Meeting: 1/20/2022
Applicant: John Holmes
Owner: John Holmes

Location: 1533 Forest Ave. **Parcel ID** 94 K J 021
District: Ft. Sanders NC
Zoning: RN-5 (General Residential Neighborhood)
Description: Queen Anne cottage, c.1900

1-B-22-HZ
APPLICATION FOR CERTIFICATE OF APPROPRIATENESS

1533 Forest Ave. 37916
Ft. Sanders NC

Owner Project Name ELEVATIONS	
Project Number	Project Number
Date	Issue Date
Drawn By	Author
Checked By	Checker
A203	
Scale	1/8" = 1'-0"

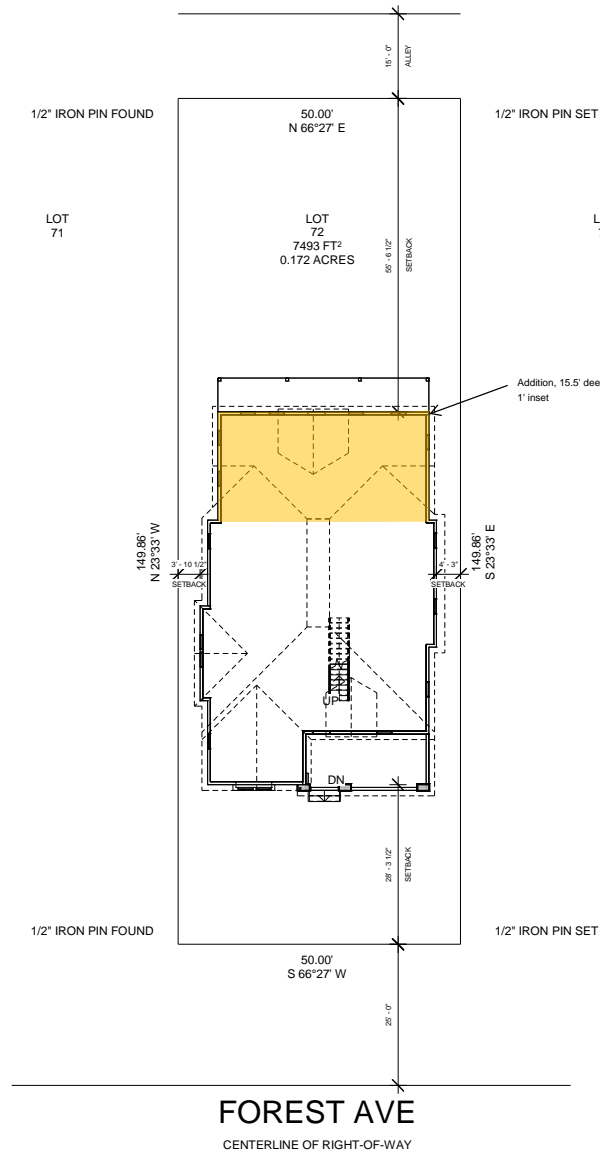
7. The applicant is requesting to remove a limited section of the rear elevation, removing the rear front-gable massing, and extending the primary roof hip with two lower cross gables at each side. While the rear gable massing is most likely an original element to the house, it is not a character-defining feature and reconstruction of this section meets the design guidelines.

8. The proposed addition is large, adding approximately 19' in length to an approximately 46' wide existing house. Similar to the recent addition at 1319 Forest Avenue (7-F-21-HZ), the applicant has broken up the substantial two-story addition with additional roofline complexity, slightly projecting bays, and new siding patterns on gable fields. The rear elevation includes the primary hipped-roof massing with cross gables, a gable-roof dormer, and a flat-roof porch. The revisions to this design reflect recommendation of the neighborhood, which include to break up the massing and shape of the addition with projecting bays that are similar in scale to the original façade bay.

9. The proposed rear addition contains sufficient complexity to break up the large rectangular massing, but as much of the house's original roof form, window layout, and projecting bays should be retained as possible. On the right side elevation (side elevation 1 on drawings), the leftmost gable-roof projecting bay should be retained in place, along with the original window placement and cornerboard.

10. The application also includes the reconstruction of the façade dormer. The overall form, placement, and proportions of the front-gable roof dormer should be maintained.

11. The replacement door on the façade meets design guidelines as a half-light door appropriate for a Queen Anne cottage. The proposed replacement one-over-one, double-hung vinyl windows also meet Fort Sanders design guidelines. The projecting hipped-roof bay window on the façade should be retained, including the decorative trim surrounding the windows. The original attic vent on the façade should be maintained.

- 1) Final site plan to reflect City Engineering requirements for parking;
- 2) Revision to right side elevation, retaining the leftmost projecting bay and cornerboard;
- 3) Installation of appropriate front porch supports above brick piers;
- 4) Retention or replication of appropriately-sized cornerboards and window trim
- 5) Retention of façade hipped-roof bay window and decorative trim, along with original attic vent on front-gable massing;
- 6) Front-gable roof dormer to be reconstructed in original design and placement.

Owner	
Project Name	
SITE PLAN	
Project Number	Project Number
Date	Issue Date
Drawn By	Author
Checked By	Checker
A201	
Scale	1/16" = 1'-0"

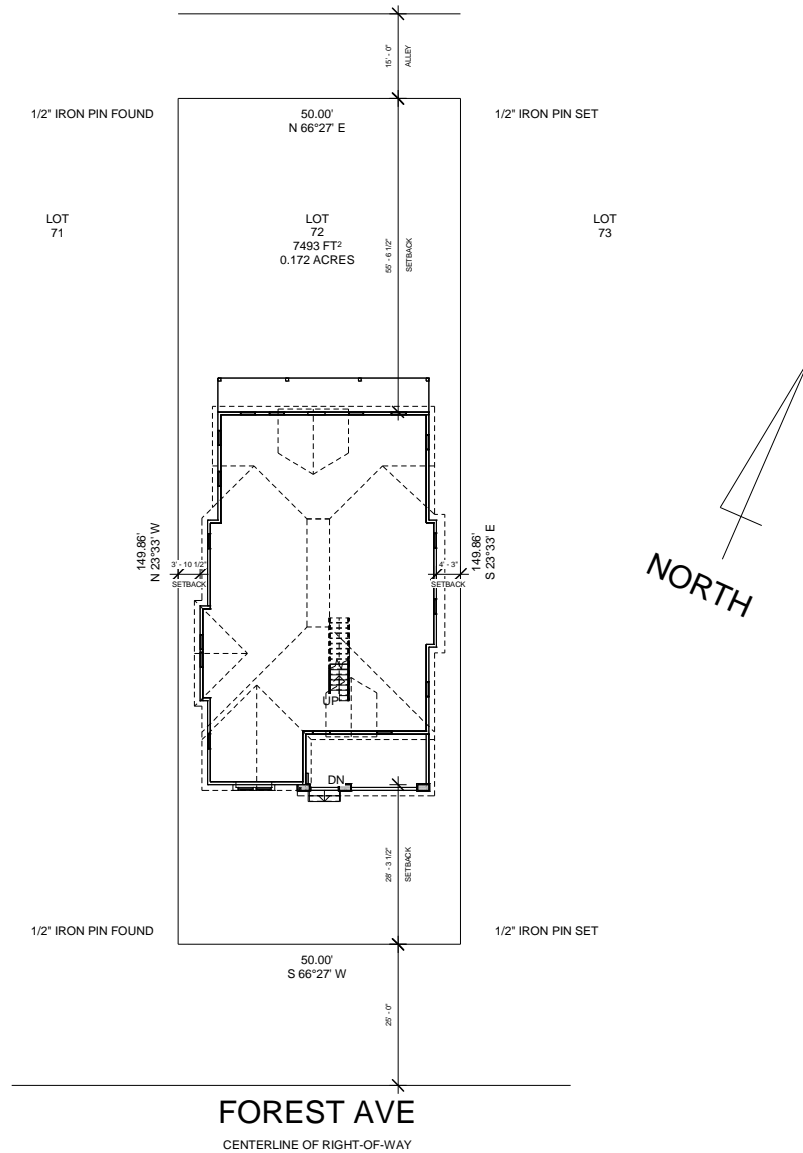
2. The provided site plan meets the dimensional standards of the RN-5 zoning. Final modifications to the site plan will be necessary to meet City Engineering standards for parking. The house and parking area need to remain below 45% impervious surface for the RN-5 zoning. The final site plan could be approved by staff, provided there are no substantial modifications to the addition's design and placement.
